7215 Cedar Avenue
Takoma Park H.D.

APPLICATION FOR HISTORIC AREA WORK PERMIT

HISTORIC PRESERVATION COMMISSION STAFF REPORT

Address: 7215 Cedar Avenue Meeting Date: 9/23/92
Resource: Takoma Park Historic District Review: HAWP/Alt.
Case Number: 37/3-92A Tax Credit: No
Public Notice: 9/10/92 Report Date: 9/16/92
Applicant: P. Blizzard/D. Brown Staff: Nancy Witherell

SIDE ELEVATION
1/4" = 1'-0"

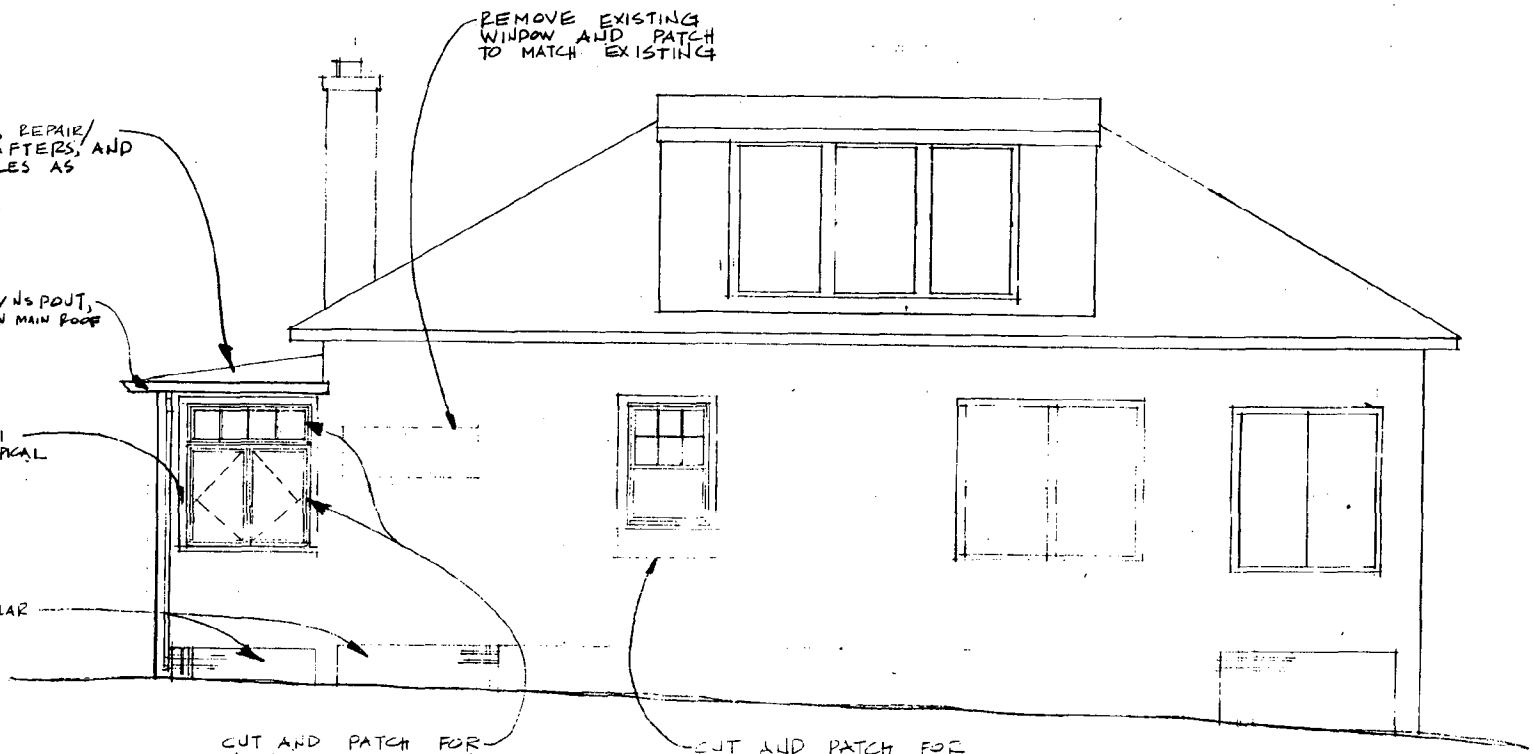
The applicants would like to enclose a rear porch as part of a kitchen expansion; the footprint of the house would not be altered. The applicants propose raising the sill of a sash window on the side elevation and replacing the existing sash with a 6/1, single-glazed sash. Window alterations on the existing rear porch include the installation of casement windows with four-light transoms above. Of the two existing four-light windows extant on the side elevation, one will be moved and the other opening will be closed. On the rear, a window opening will be lowered to accommodate a new wooden door with a nine-light, single-glazed opening. Rear concrete steps and a metal railing will be replaced with wooden steps and a wooden top porch railing above square balusters. The millwork will be painted. Throughout, the patching of wall surfaces will be achieved with painted asbestos wall shingles to match the existing.

The staff commends the applicants and architect for selecting new multi-paned sash with single glazing, and for continuing the use of the four-light transoms, also single-glazed.
